**Planned Unit Development (PUD)—
Brixmor Property Group, LLC**

RECOMMENDATION REPORT

CASE NUMBER: PPUD-19-0002

RE: Planned Unit Development (PUD) Amendment
Initial Review
Brixmor North – Southport West

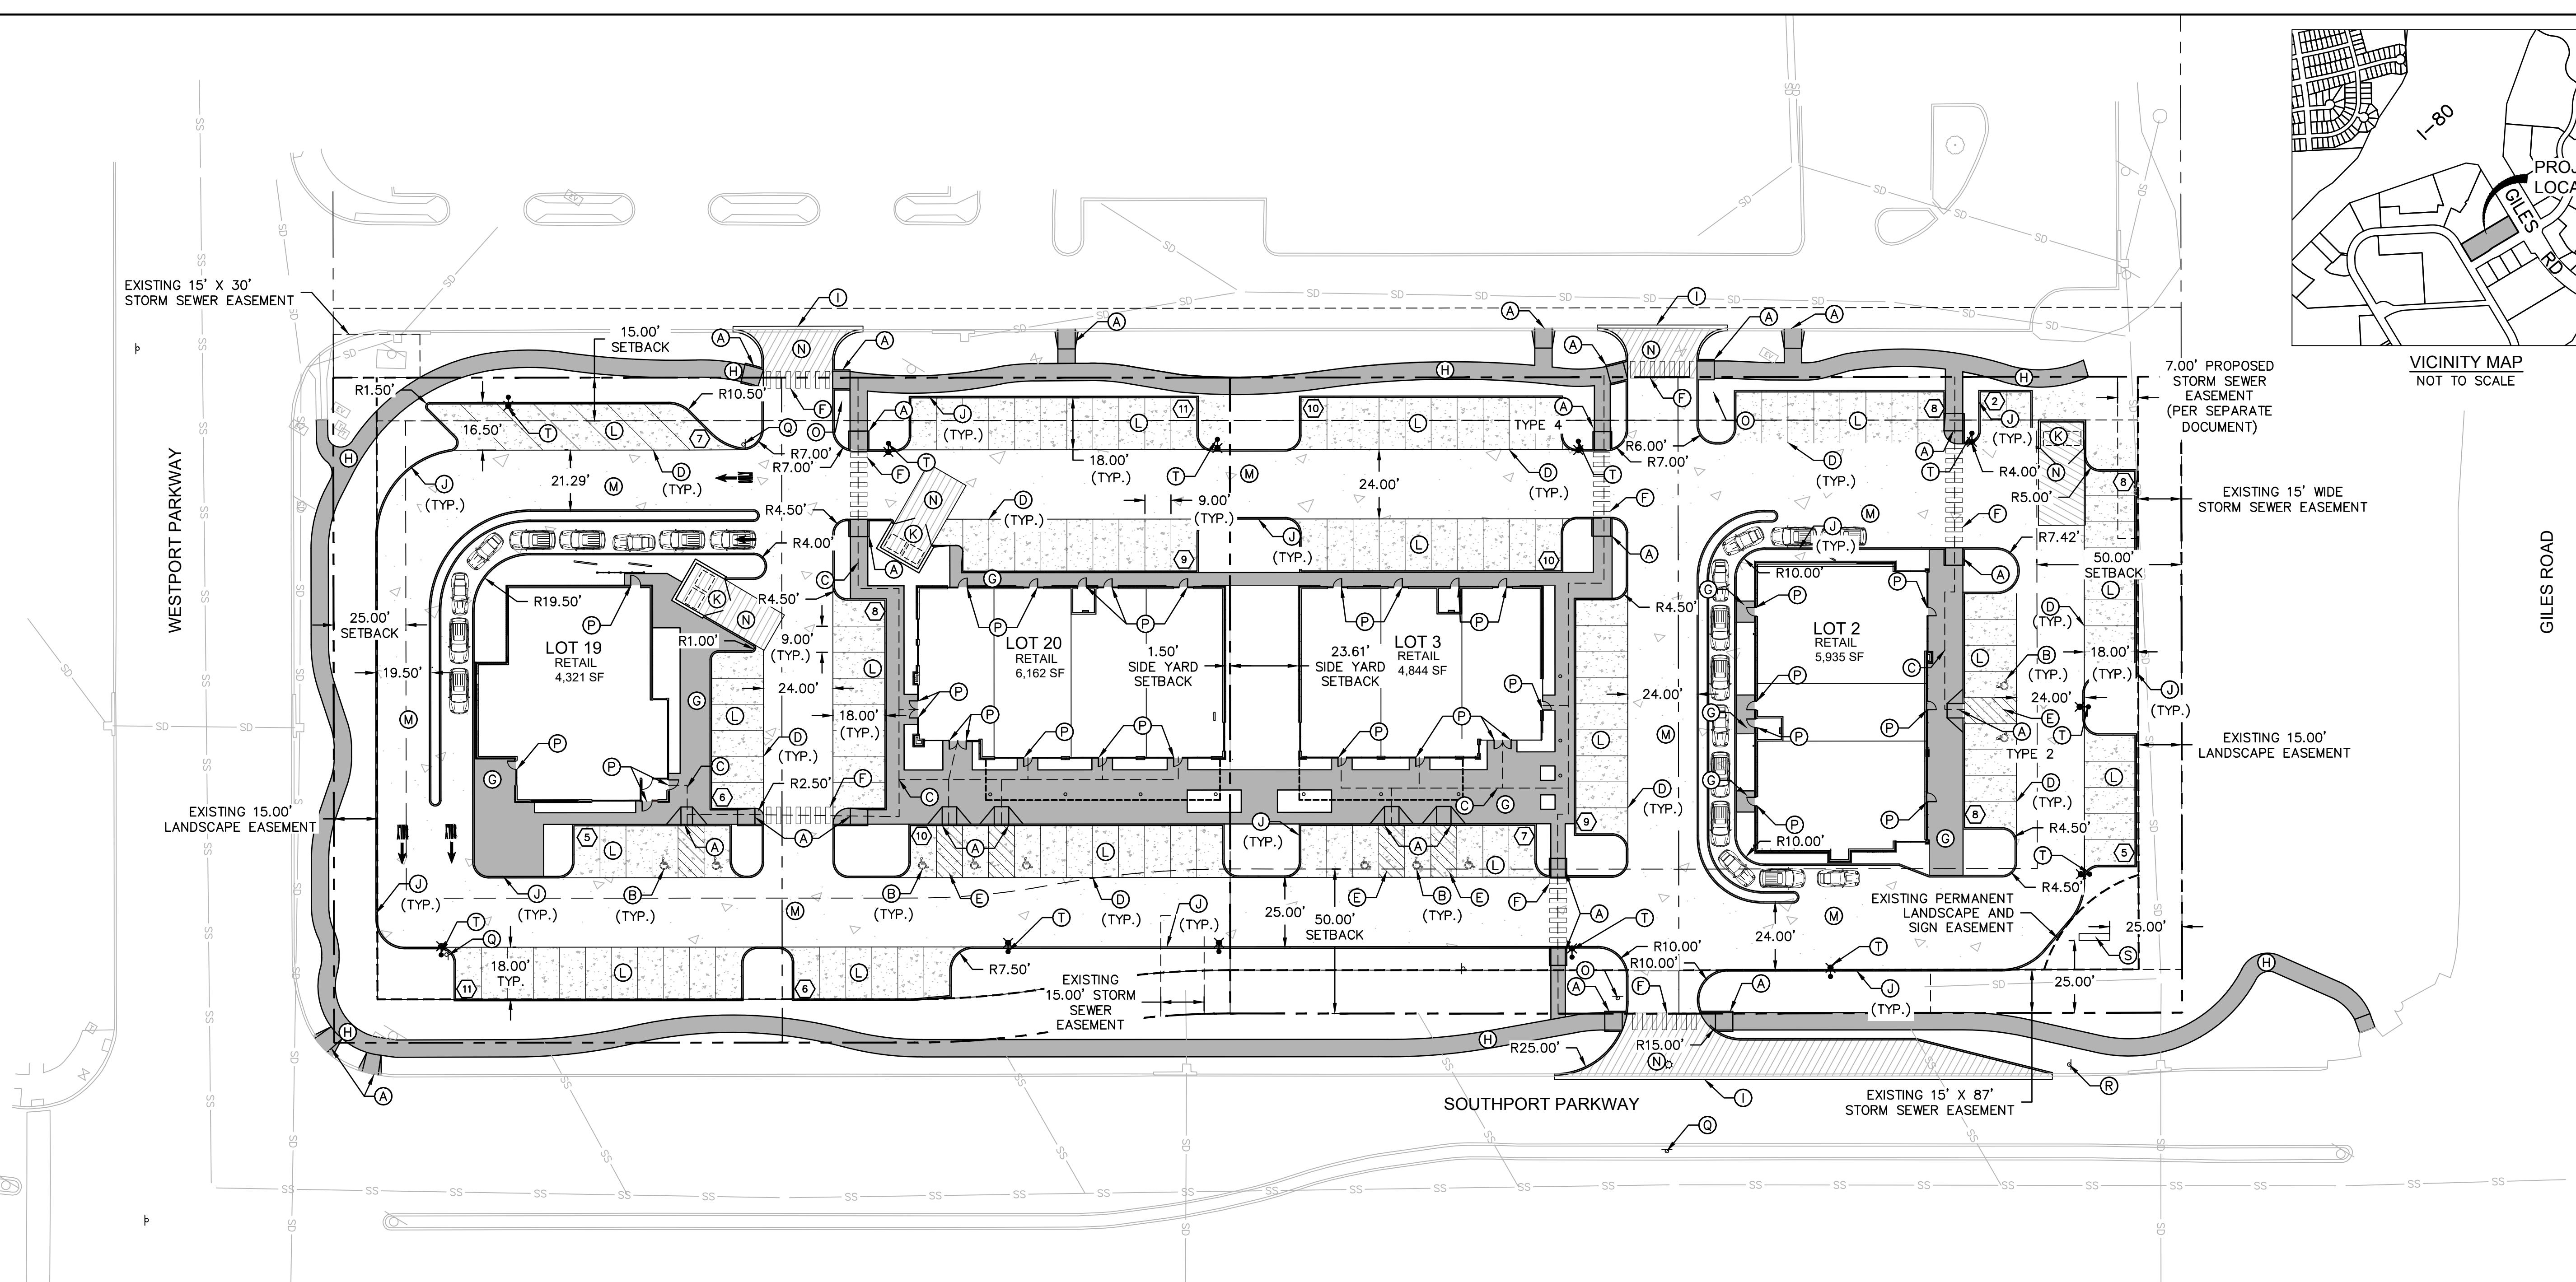
Sheet C2.1

- Parallel parking stalls in front of 4,844 sf building are too small and will potentially add congestion. Confirm parking count is adequate per building use.

- Proposed building on Lot 20 does not meet the 15 ft side yard setback of the C-3 District. Dimension proposed setbacks from the side yard lines.
- Building coverage does not appear to be an issue, but data should be set forth on the site layout plan to show compliance with the 60% limitation to conform with Article 5.15.04.10.
- Proposed locations for potential project directory or center identification signs need to be shown

Sheet C2.1

- Proposed public sidewalk needs to be 6 inches thick and not closer than 6 feet to back of curb. **Response: Notes have been revised.**

- Pavement thicknesses in the Site Key Notes need to be filled in. **Response: This has been completed.**
- Need dual ADA ramps at Southport Parkway and Westport Parkway intersection (currently only one ramp is shown). **Response: Ramps have been revised.**

- Walk connections to hotel not shown. **Response: Connection to the hotel has been added.**
- Walk connections to public sidewalk not shown. **Response: Connection to public sidewalk have been provided.**

- Traffic circulation to the buildings with drive-up windows needs clarified, appears that one-way traffic may be intended but not clearly shown. **Response: The site has been modified to provide a 3' island for separation of drive-thru traffic and circulating traffic.**

- The drive-up lane at rear of bldg. on Lot 2 needs barrier from inbound traffic to avoid confusion/accidents. **Response: The site has been modified to provide a 3' island for separation of drive-thru traffic and circulating traffic.**

- Parallel parking stalls in front of 4,844 sf building are too small and will potentially add congestion. Confirm parking count is adequate per building use. **Response: This parking has been removed and parking counts provided.**

- Radii at the proposed RIRO access on the interior turns should be greater. **Response: This has been revised.**
- The Site Information Table lists the existing and proposed zoning as "MU". Both should be listed as "C-3 PUD with a Gateway Corridor Overlay". **Response: This has been revised.**

Ordinance 1267 states that building setbacks shall meet C-3 zoning unless otherwise approved by City Council as part of the final PUD. The setbacks in the site information table and on the map of C2.1 need to depict the setbacks set forth within Section 5.12.06.01 of the Zoning Ordinance. Specifically, The building setback dimension along Giles Road and Southport Parkway needs to be adjusted to 50 feet; 25 feet along Westport Parkway; and 15 feet along the property line shared with the hotel. **Response: Setbacks along the roadways have been revised and noted.**

- Proposed building on Lot 20 does not meet the 15 ft side yard setback of the C- 3 District. Dimension proposed setbacks from the side yard lines. **Response: Per conversations with staff, this is an interior lot line and would not need to meet this requirement. *"In review of the regulations, Section 5.15.04.16 will allow for up to a zero lot line setback for lot lines that are interior to the development. Hence, an Administrative Plat will not be required."***

- Building coverage does not appear to be an issue, but data should be set forth on the site layout plan to show compliance with the 60% limitation to conform with Article 5.15.04.10. **Response: A table has been provided with the building coverage.**

- Proposed locations for potential project directory or center identification signs need to be shown. **Response: Directory sign location has been noted within the existing signage easement.**

Sheet C2.1

- The traffic flow around the building in Lot 19 is not clearly indicated; appears the traffic is intended to travel one way.
- Applicant needs one additional walking connection north to the hotel that lines up with the side door to the building. Confirm with hotel site plan.

- Although developments are provided some flexibility in regards to setbacks through the use of a PUD, the Planning Commission and City Council will need to know what revised setbacks they are reviewing. Hence, the proposed side yard setbacks for the buildings planned for Lot 3 and Lot 20 need to be adequately dimensioned on the PUD Site Plan.

- The site plan depicts a “monument sign” in the southeast corner of the development. Applicant needs to clarify if this is the type of sign requested to be used. If a multi-tenant style sign is planned, the labeling needs to be changed to “Project Directory” or “Center Identification”. Please note the spacing requirements for Center Identification signage in Article 7 of the zoning ordinance when considering the signage plan and related impacts on future development of the property on the south side of Southport Parkway.

- The traffic flow around the building in Lot 19 is not clearly indicated; appears the traffic is intended to travel one way
Response: The traffic is intended to be one-way traffic. Direction arrows and signage have been added.

- Applicant needs one additional walking connection north to the hotel that lines up with the side door to the building. Confirm with hotel site plan
Response: This has been added and coordinated with hotel site configuration.

Response: Dimensions for the internal setbacks have been provided.
- Confirm adequate parking for Lot 2 given the proposed use(s) of the building
Response: A breakout of parking per lot has been provided.

Response: This has been revised to reflect a Project Directory signage note.
- Setbacks for the signage based on the sign type mentioned above and the PUD ordinance need to be depicted for the sign in the southeast corner of the development.

GRADING PLAN
 PUD PLANS
 BRIXMOR NORTH
 LOTS 2, 3 19, 20

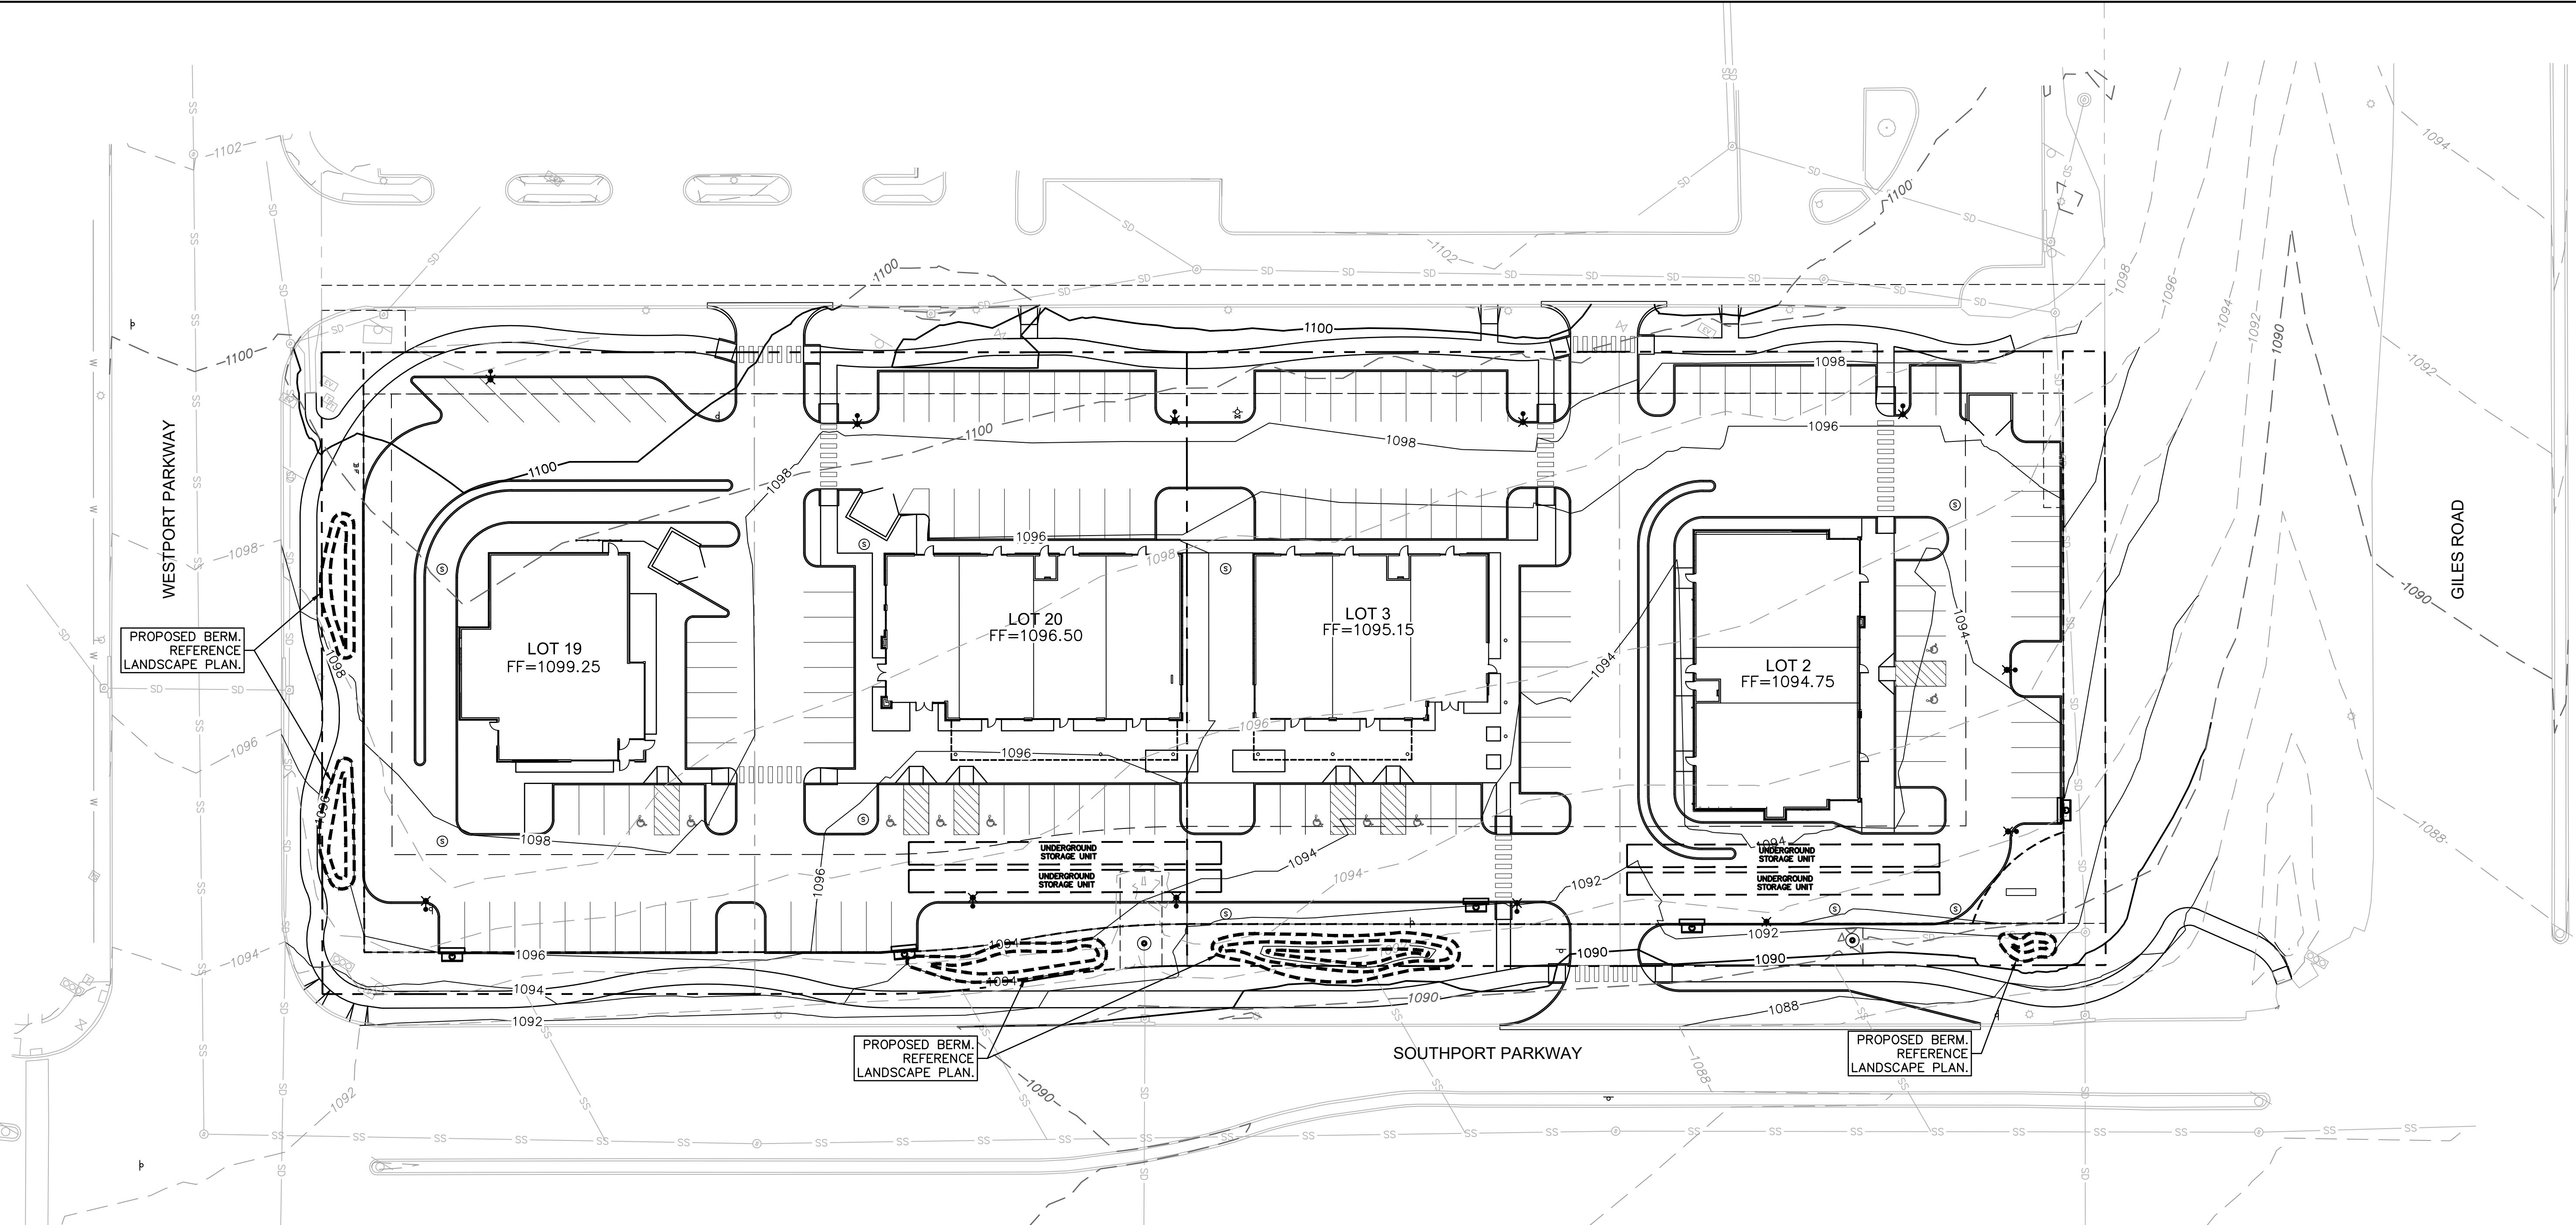
Sheet C3.1

- Grading work will require a grading permit. Refer to the Master Fee Ordinance for details.
- Grading plan needs to address a conceptual design of water quality and 2-year peak flow detention, such as indication of bio-basins or under parking lot facilities.
- As there are drainage capacity limitations at the culvert crossing near under the rail road southeast of Giles road, all catchments drain that drain into said basin should be held to a no-net increase of the predevelopment flows until the drainage culverts at the railroad is up-sized to account for post-developed conditions for a 100-year return frequency.
- The grading plan submitted does not depict the required berthing of the landscaped areas along Westport Parkway as required per Section 8(B)(ii)(c) of the Southport West PUD.

Sheet C3.1

- Grading plan needs to address a conceptual design of water quality and 2-year peak flow detention, such as indication of bio-basins or under parking lot facilities. **Response: A water quality structure has been provided along with under parking storage to ensure we are not increasing the offsite flow.**

- As there are drainage capacity limitations at the culvert crossing near under the rail road southeast of Giles road, all catchments drain that drain into said basin should be held to a no-net increase of the predevelopment flows until the drainage culverts at the railroad is up-sized to account for post-developed conditions for a 100-year return frequency. **Response: A water quality structure has been provided along with under parking storage to ensure we are not increasing the offsite flow.**

- The grading plan submitted does not depict the required berthing of the landscaped areas along Westport Parkway as required per Section 8(B)(ii)(c) of the Southport West PUD. **Response: Berthing has been added and noted on the plan.**

Sheet C3.1

- Although the engineering consultant's response letter notes adjustments to the grading plan in relation to the berthing required as per Section 8(B)(ii)(c) of the Southport West PUD, the PUD documents submitted do not sufficiently depict the required berthing.
